STAFF REPORT	
COMMUNITY DEVELOPMENT DEPARTMENT

SUBJECT: Avani Neighborhood AZ, PP
[H-2023-0049](#)

I. PROJECT DESCRIPTION

Annexation of 35.086 acres of land to the R-15 (Medium-high-density residential) zoning district; and Preliminary Plat consisting of 256 building lots and 25 common lots on 33.71-acres of land in the R-15 zoning district for Avani Neighborhood Subdivision.

FIGURE 1

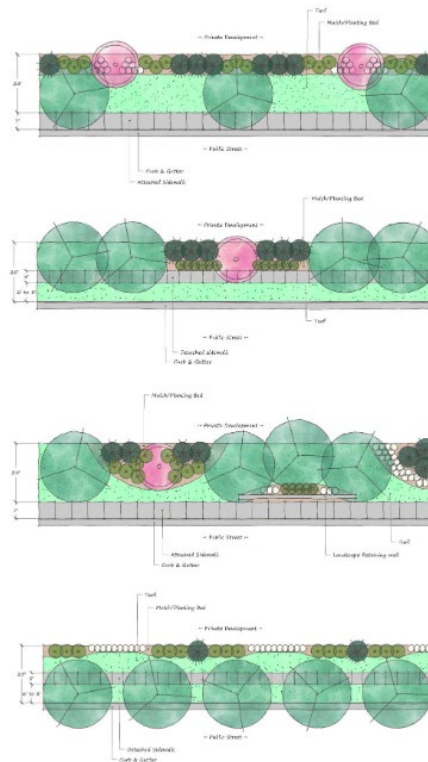
Landscaping (UDC [11-3B](#)): A 25-foot wide street buffer is required is required along all arterial streets (i.e. S. Black Cat Road) in residential districts. A 20-foot wide street buffer is required along all collector streets (i.e. Vantage Point Way) a collector street, per UDC [Table 11-2D-7](#), landscaped per the *updated* standards listed in UDC [11-3B-7C](#). **The proposed buffer along the southern half of Black Cat Road appears to be 20-feet in width and should be 25-feet in width. The 20-foot wide buffer along the new collector street (Vanguard Way) appears to meet the requirements of the UDC code; however, there is a lack of a combination of planters (shrubs and rock mulch) within both of the buffers (refer to the figures below).**

An 8-foot wide parkway with Class II trees is required along all local streets per UDC [Table 11-2D-6](#), landscaped per the standards listed in UDC [11-3B-7C](#).

D. Common Drive Exhibit —*NOT APPROVED*

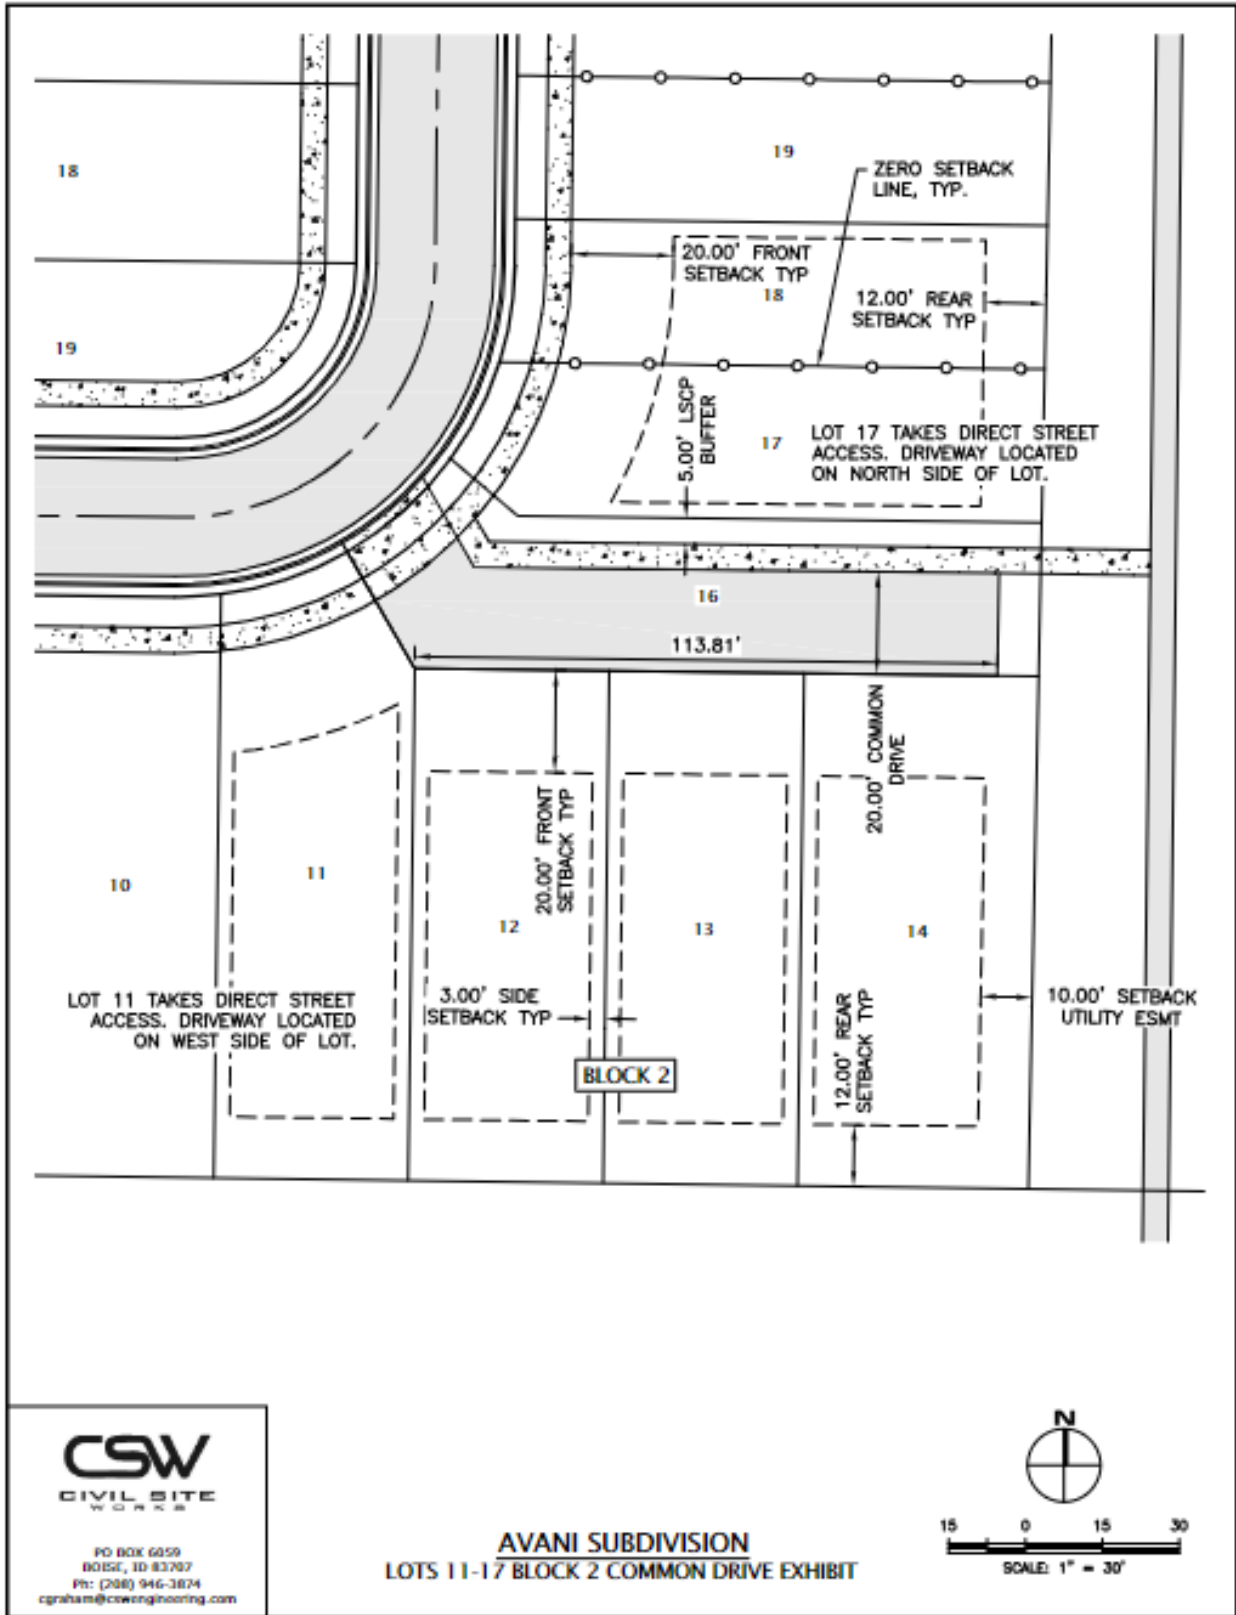
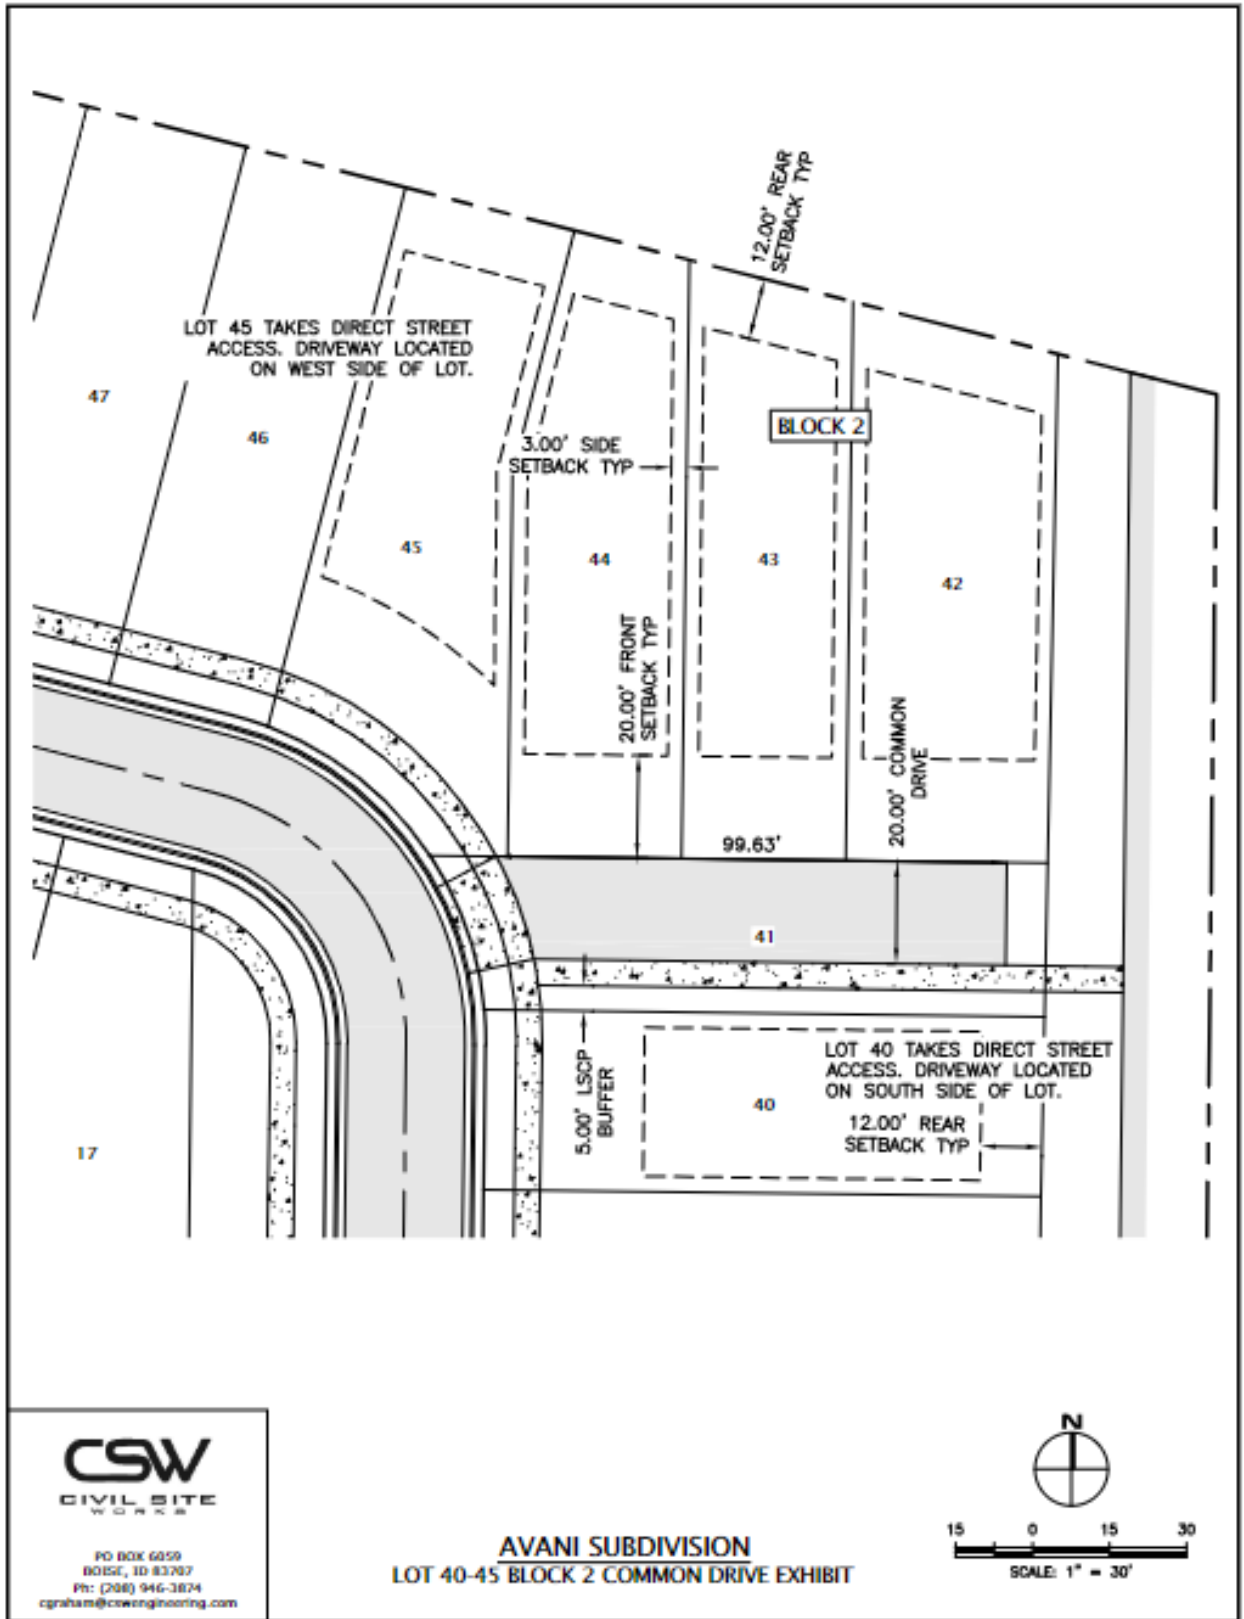
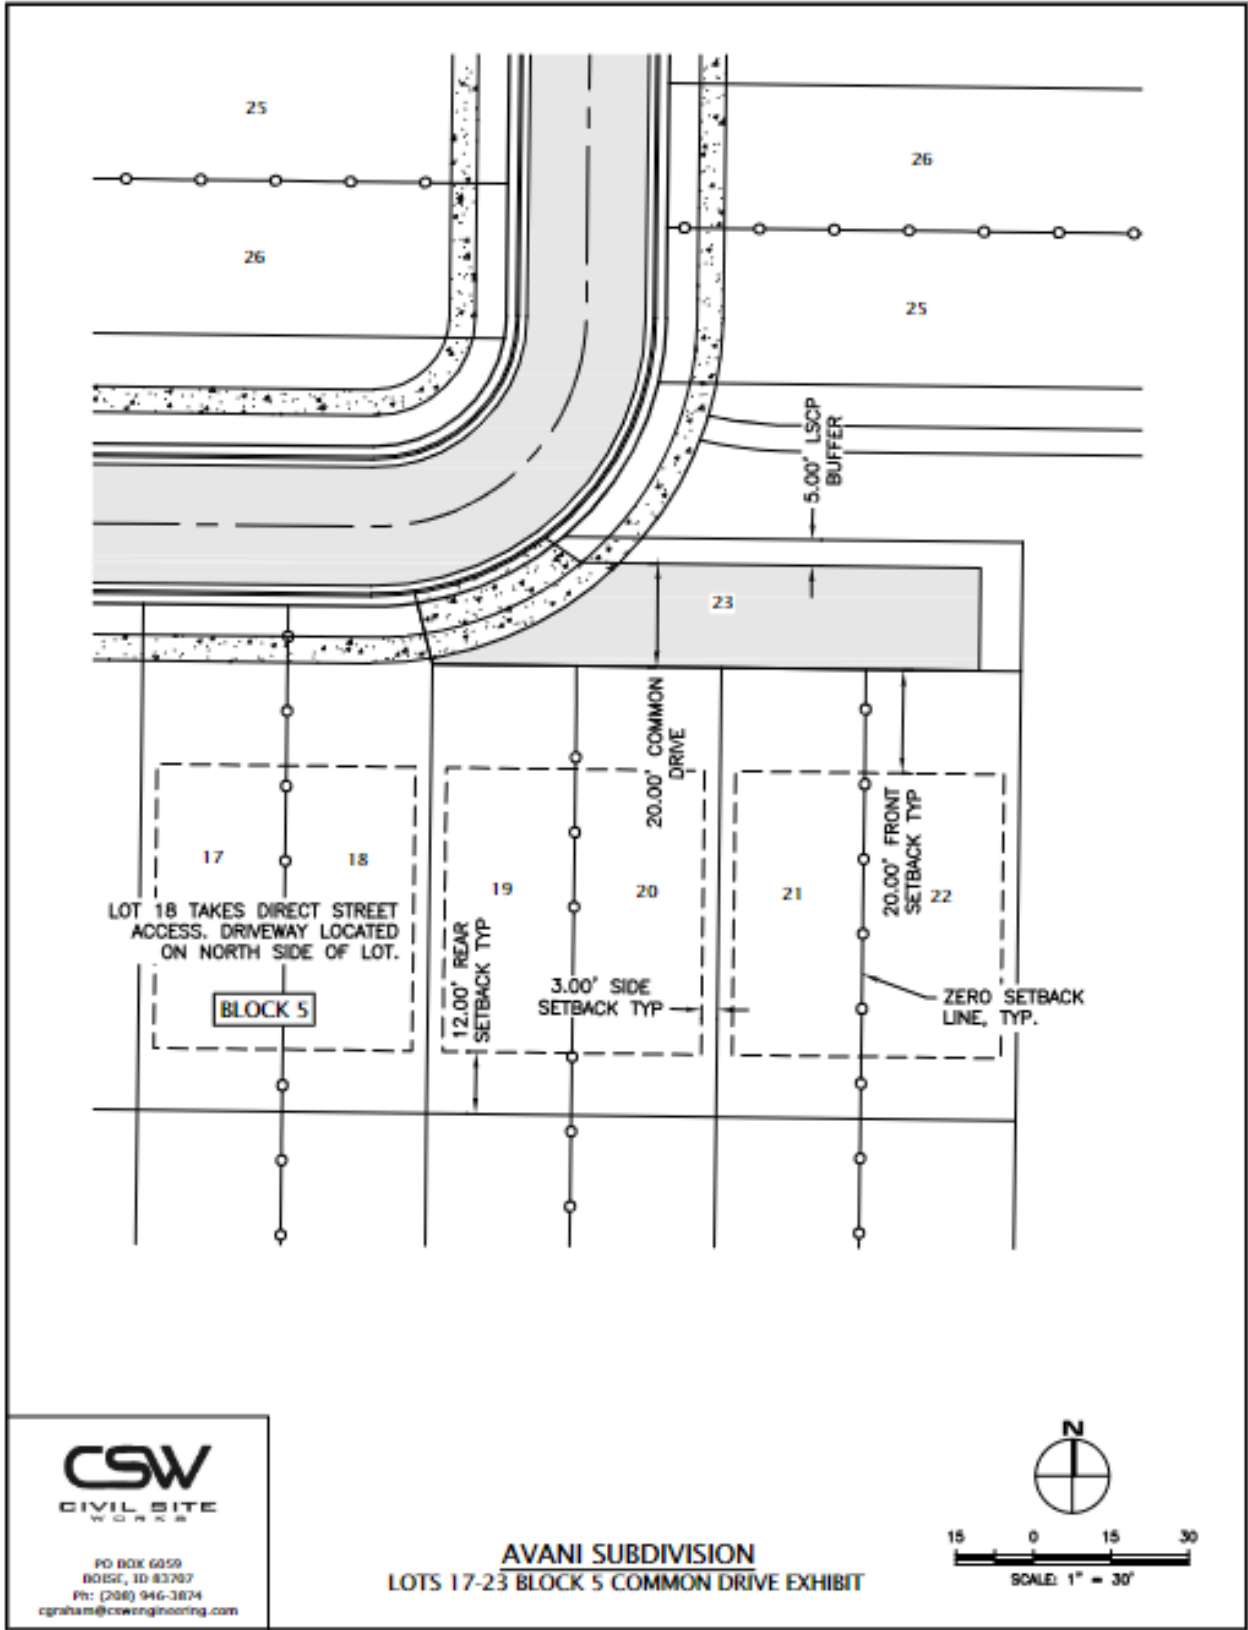
Common Driveway (UDC [11-6C-3D](#)): Six (6) common driveways are proposed within the development of the site on Lot 42, Block 1, Lot 16, Block 1, Lot 41, Block 2, Lot 33, Block 2, Lot 16, Block, 2, and Lot 23, Block 5. Common driveways are allowed to serve a maximum of four (4) dwelling units; in no case shall more than three (3) dwelling units be located on one (1) side of the driveway. **A total of four (4) dwelling units are proposed on the south side of driveway for Lot 23, Block 5; the final plat and common driveway exhibit shall be revised to depict a maximum of three (3) units on one (1) side of the driveway as required; or, alternative compliance may be requested as set forth in UDC [11-5B-5](#).**

A perpetual ingress/egress easement is required to be filed with the Ada County Recorder for the common driveway, which shall include a requirement for maintenance of a paved surface capable of supporting fire vehicles and equipment. **This may be accomplished through the depiction of the easement on the face of the final plat and an accompanying note. If a separate easement is recorded, a copy should be submitted to the Planning Division with the final plat for City Engineer signature.**
